Access Compliance Report Public Rights-of-Way (Curb Ramps)

Main Street: FOSTER_RD Cross Street: ST_ALBANS_DR Location: NE

ADA ID: RPRK211221115205 Ramp Type: Type 1 - Perpendicular Diagonal Initial Pass/Fail: Pass Overall Compliance: No Severity Score: 10

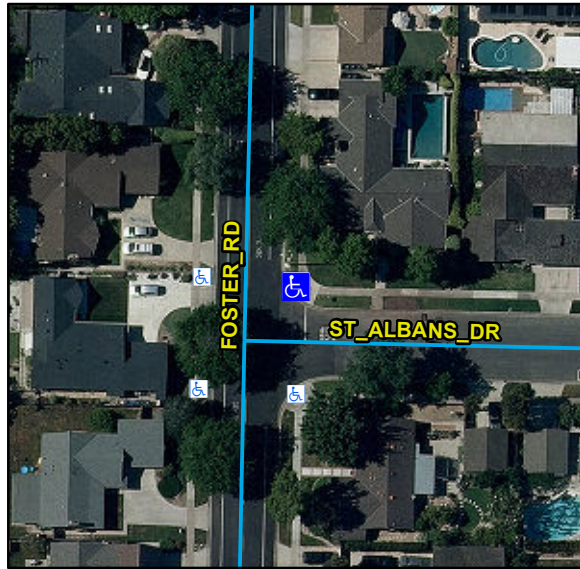
Remove & Replace Curb Ramp With Two New Directional Ramps or Equivalent. Gutter Ponding Observed.

Possible Solutions:
